Skyline Mine

RE: Removal of NOG Shaft, Canyon Fuel Company, LLC, Skyline Mine, C/007/005, Task #6054

Removal of NOG Shaft

Response to Task ID #6054

SCALE: 1" = 2000'	DATE: 9/24/01	CK.BY: G. Galecki	REVISION:
DWG. NO.: 1.6-3		DR.BY: JCA	13
CAD FILE: 1.6-3REV12			1-2-20

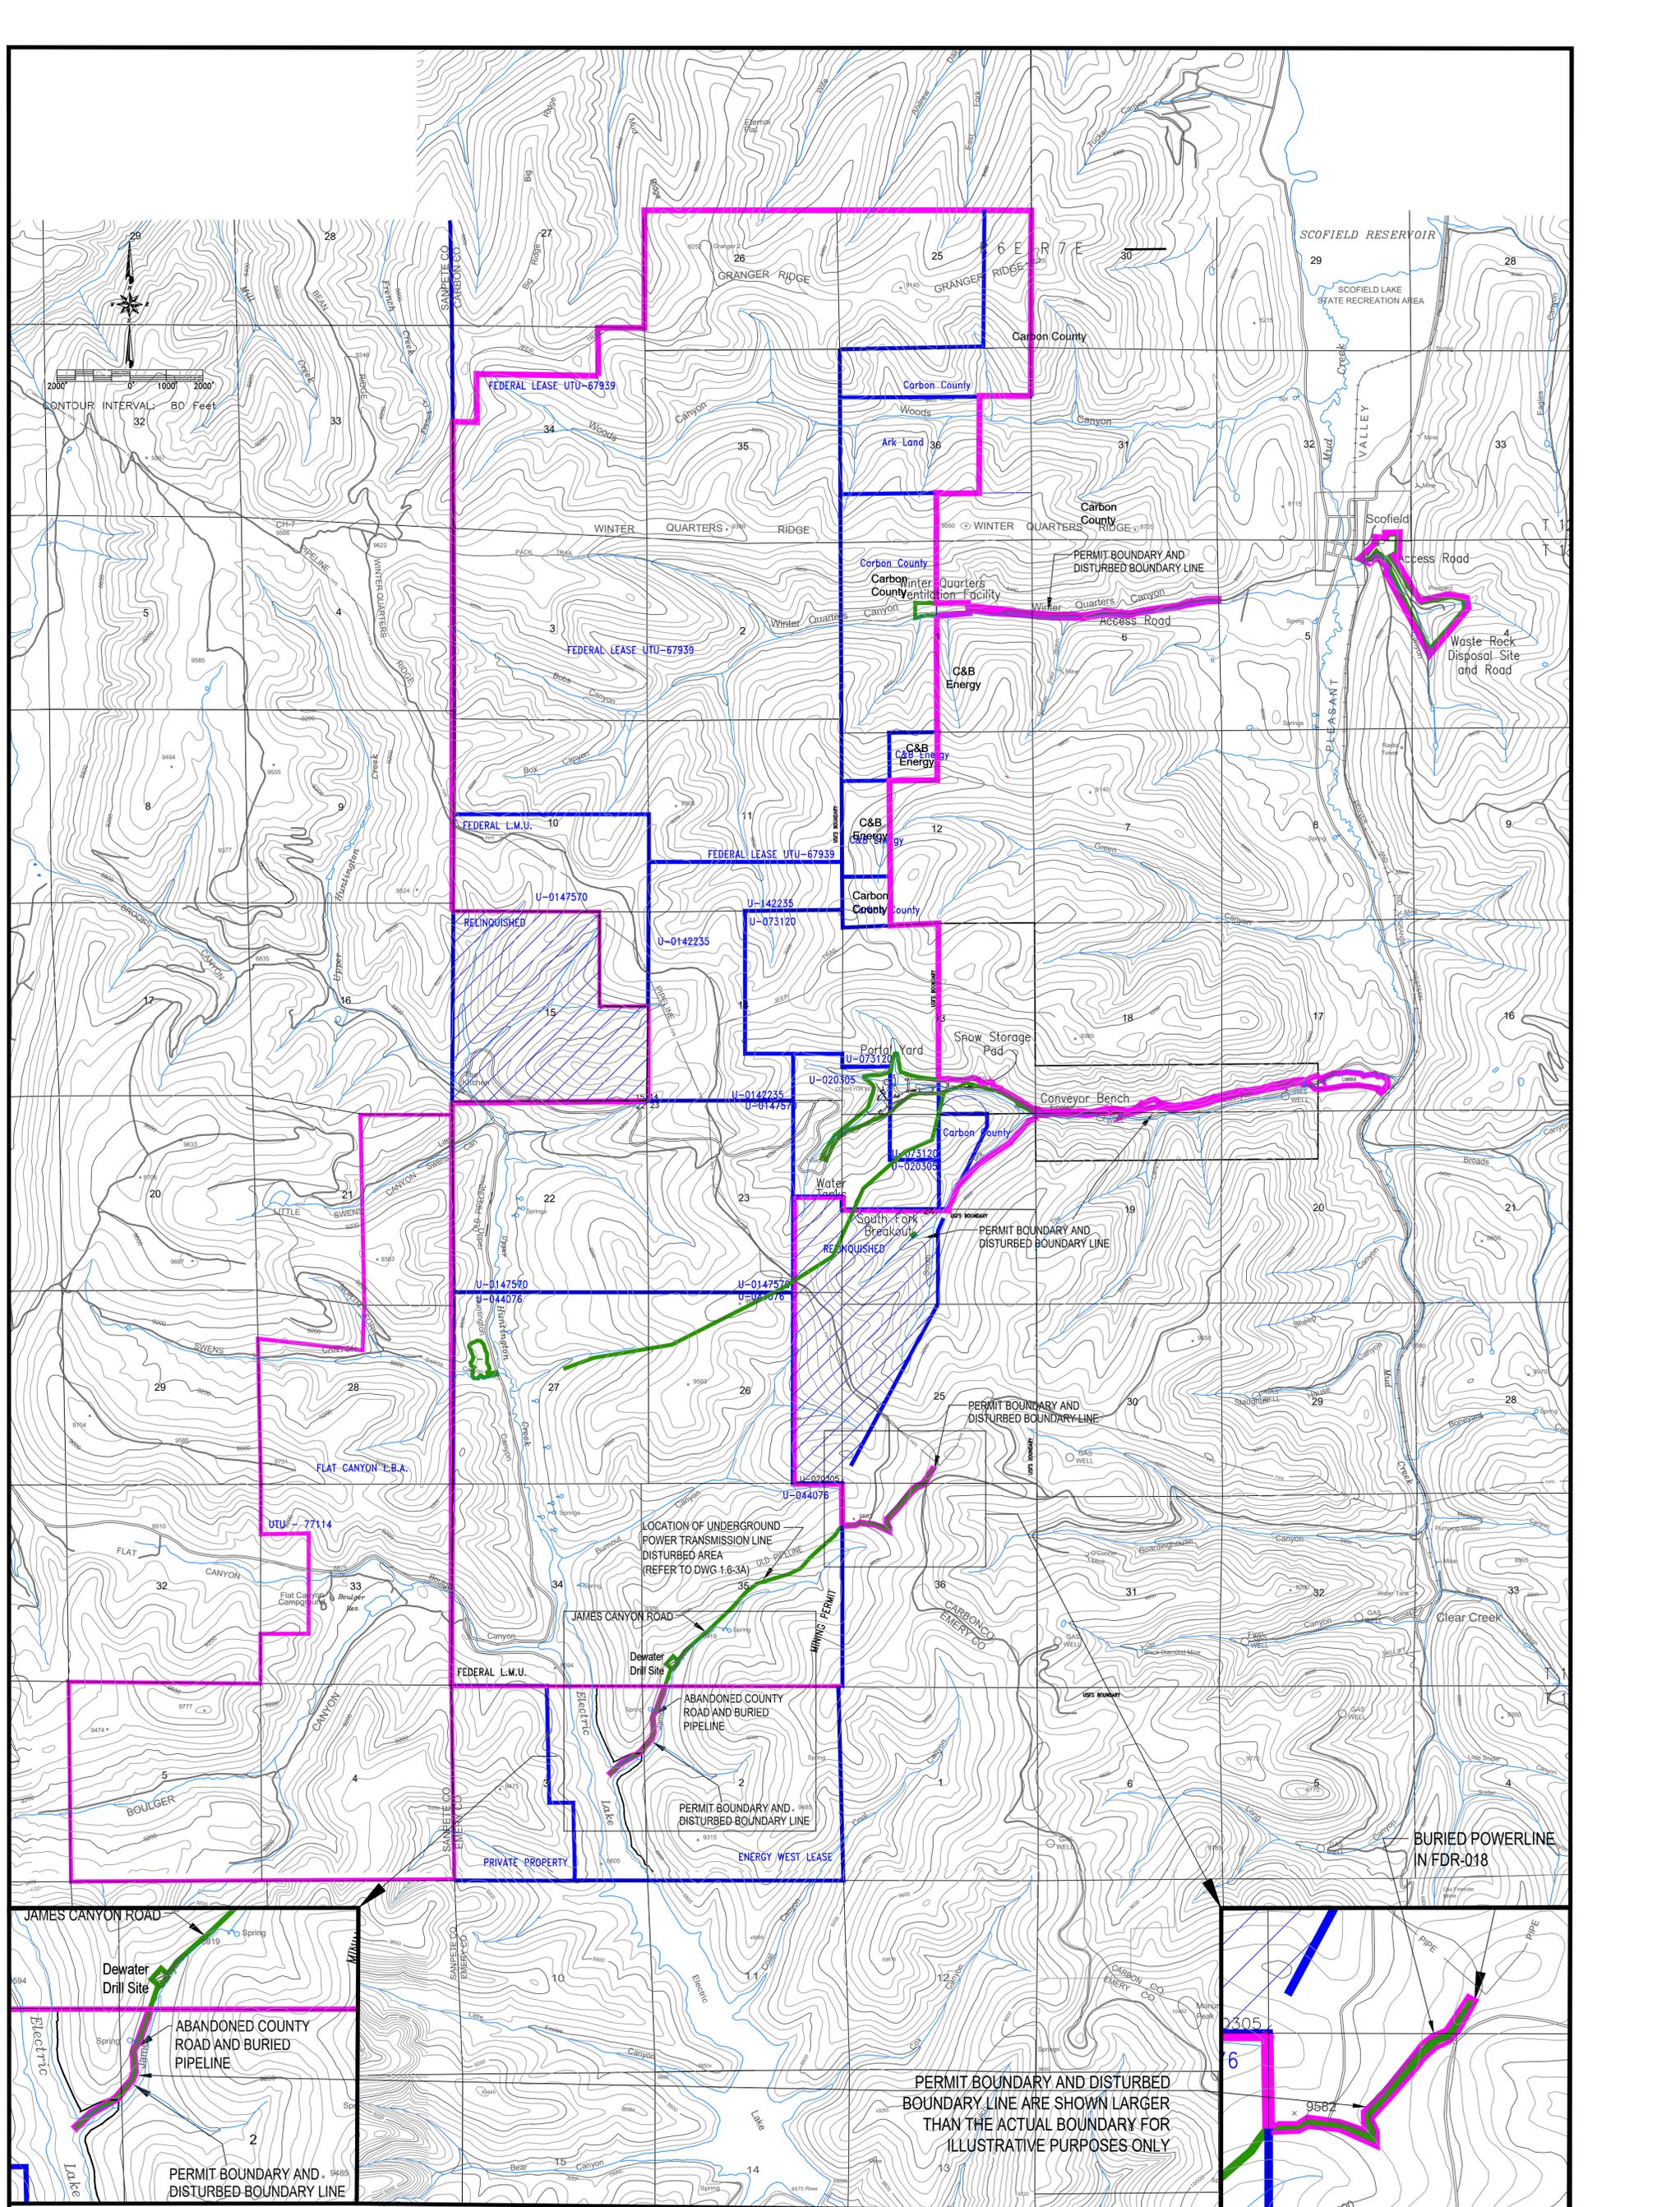
R645-301-121.200: 1) correct acreage figure in first paragraph on p. 1-37; 2) Table 2.12.2-1 on p. 2-128 does not include NOG; 3) Remove NOG from Plate 1.6-3 table in legend; 4) TOC lists NOG shaft hydrology report in Appendix 5, Volume3 – remove? **pburton**

R645-521.141, -521.162: remove NOG from Plate 1.6-3 acreage table. **jeatchel**

- 1) [Paragraph 1 has been changed from 139.81 to 136.45 \(with the 136.45 acreage checked for accuracy; 2\) the revised Table 2.12.2-1 has been submitted; 3\) Removed NOG 3.0 acres from table in Plate 1.6-3, reduced acreage to 136.45 in same table, added table modification to revision description; 4\) All supporting reports for the NOG will be removed from the M&RP.](#)

[Removed NOG 3.0 acres from table in Plate 1.6-3, reduced acreage to 136.45 in same table, added table modification to revision description.](#)

DATE	No.	REVISIONS	BY	DATE	No.	REVISIONS	BY
AUG 02	1		SM	Oct 17	12	Removed South Fork Road	TE
NOV 02	2		SM	1/2/20	13	Removed NOC shaft from drawing and legend	TE
JUNE 07	3	MODIFIED PERMIT BOUNDARY (IBC & WASTE ROCK) SKYLINE MINES PERMIT AREA, LEASE AREAS.	BR				GG
MAR 2010	4	ADDED ADJACENT AREA, MODIFIED PERMIT AND LEASE BOUNDARIES	AB				GG
JUL 2010	5	ADDED WINTER QUARTERS ACCESS ROAD	AB				GG
AUG 2010	6	MODIFIED ADJACENT AREA	AB				GG
OCT 2012	7	Modified Adjacent Area with Lease Mod. and Relinquishments	GG				GG
July 2014	8	Corrected permit boundary to include water line from Tanks	GG				GG
April 2015	9	Added the NOC shaft pad	TE				GG
May 2016	10	Added Swens shaft pad and power line	JA				GG
Dec. 2016	11	Added Flat Canyon Lease - UTU-77114	JA				GG
